**PLANNING COMMISSION
STAFF REPORT**

REPORT DATE: April 3, 2008
AGENDA DATE: April 10, 2008
PROJECT ADDRESS: 601 E. Micheltorena Street (MST2003-00827)
 Santa Barbara Cottage Hospital Foundation Workforce Housing Project
TO: Planning Commission
FROM: Planning Division, (805) 564-5470
 Jan Hubbell, AICP, Senior Planner
 Irma Unzueta, Project Planner

The project applicant for the Santa Barbara Cottage Hospital Foundation Workforce Housing Project has submitted a request for a substantial conformance determination (Exhibit A). The purpose of this hearing is for members of the Planning Commission and the public to provide input to the Community Development Director regarding the director's determination of substantial conformance for proposed revisions to the Santa Barbara Cottage Hospital Foundation Workforce Housing Project. This hearing relates exclusively to the proposed changes to the site plan layout, project statistics and architecture associated with the project, which result from refinement of the project by the City's design review process.

FIGURE 1 LOWER LEVEL

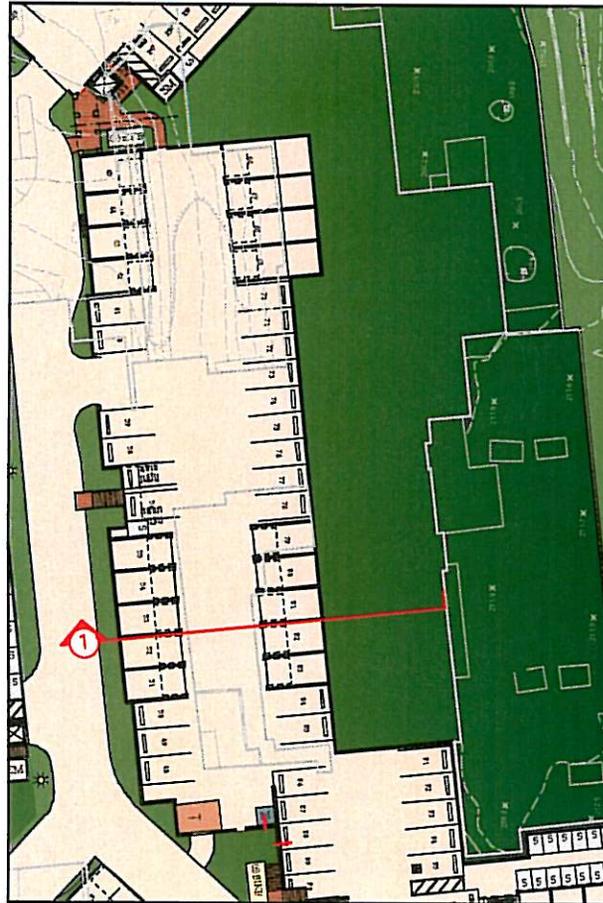
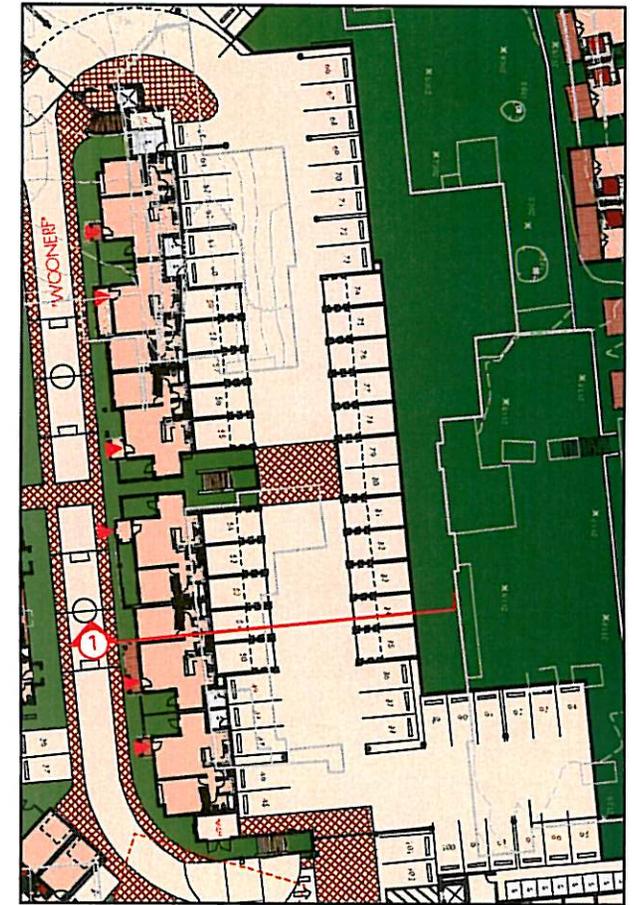
Eliminated one row of buildings at the upper level by relocating 6 units to the lower level fronting the "woonerf" (see Section). Moving these units to the lower level eliminates the large blank wall of the parking garage from facing the "woonerf", and provides flexibility for other site revisions.

FIGURE 2

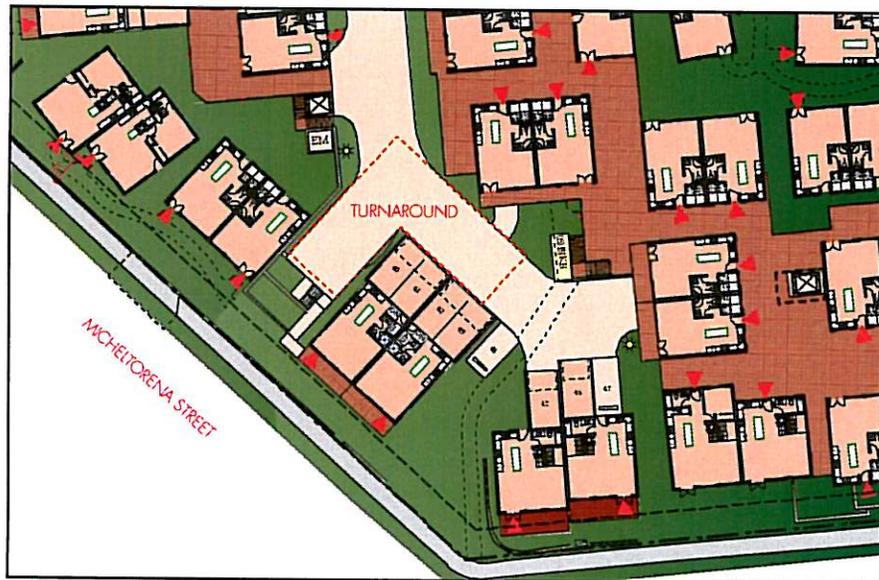
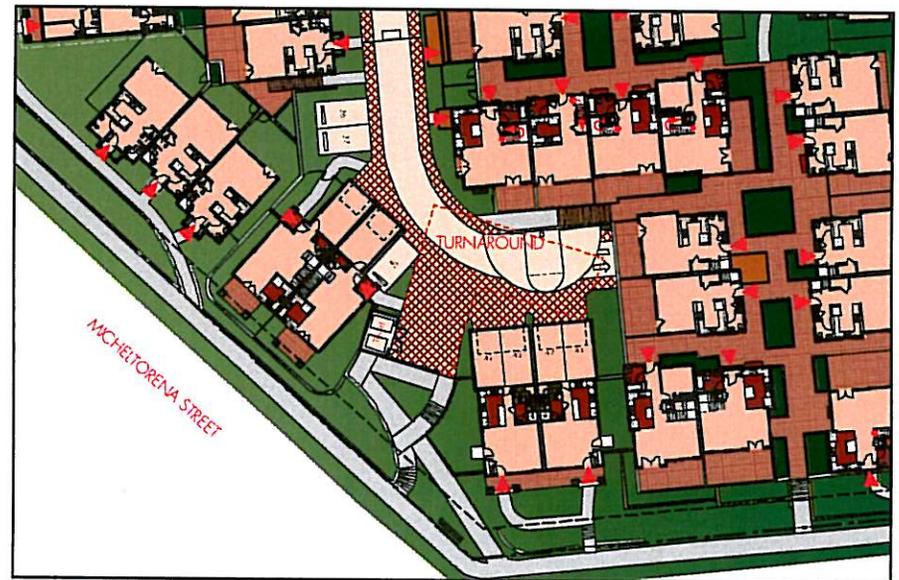
Removed one building from the Micheltorena Street frontage.
Relocated the fire turnaround and enhanced the pedestrian entrance at the Micheltorena/California street corner.

FIGURE 3

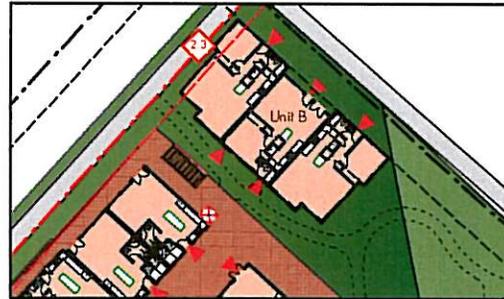
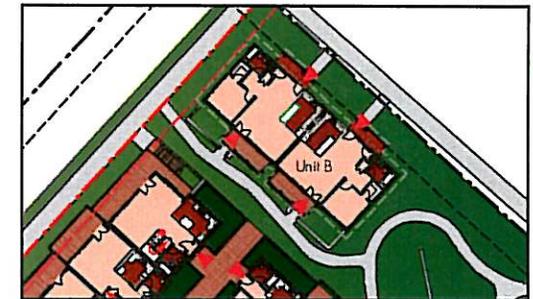
Reduced and simplified unit B (from 5 to 4 one bedroom units). Eliminated 1 modification (2.3) to allow structures to encroach into the required front yard setback.

FIGURE 4

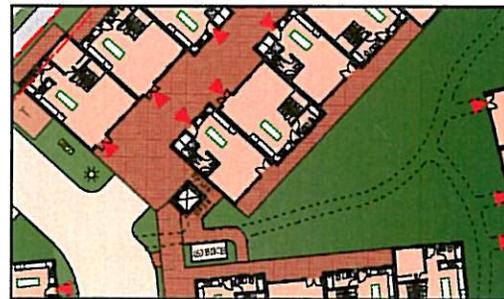
Enhanced & enlarged courtyard connection. Incorporated a new plaza space. Connected the previously separate parking garages below to allow vehicular circulation to occur within the parking structure and reduce traffic on the "woonerf".*

Floor Area Comparison / Typical Triplex

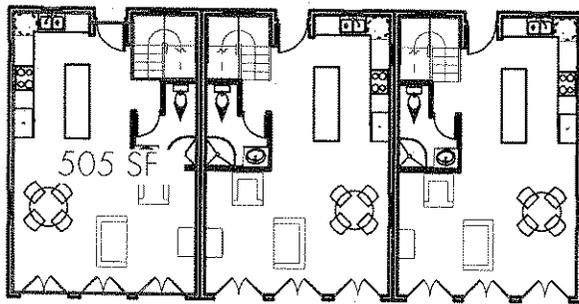
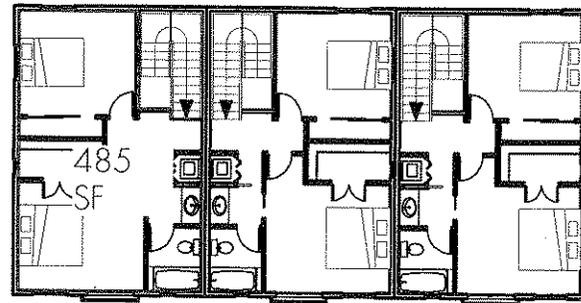
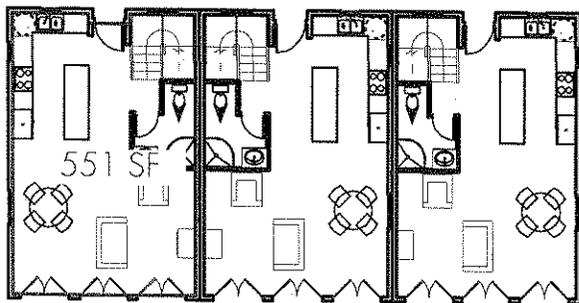
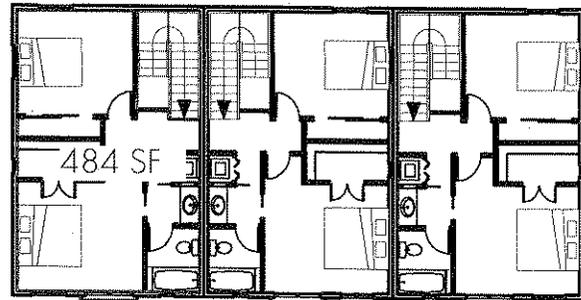
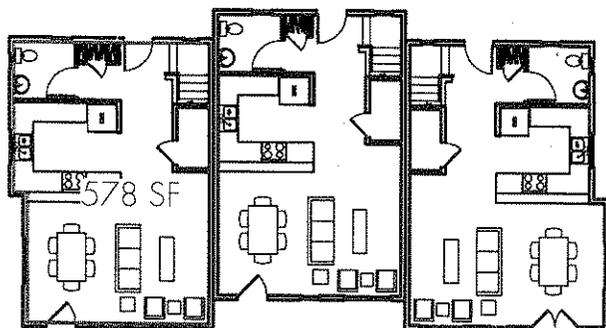
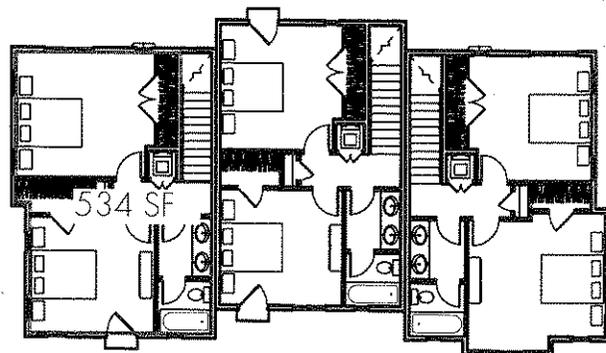
As the plans evolved through the ABR process and we responded to the Board's request for additional articulation in the architecture, the net floor area increased 5,113 sq. ft. from the reconciled amount. This increase in square footage, when spread across the 115 units, amounts to an average of 44 sq. ft. per unit, or only 22 sq. ft. per floor per unit. We have provided a floor area comparison illustration showing the original floor area discrepancy and the increase resulting from ABR Review for a typical triplex unit.
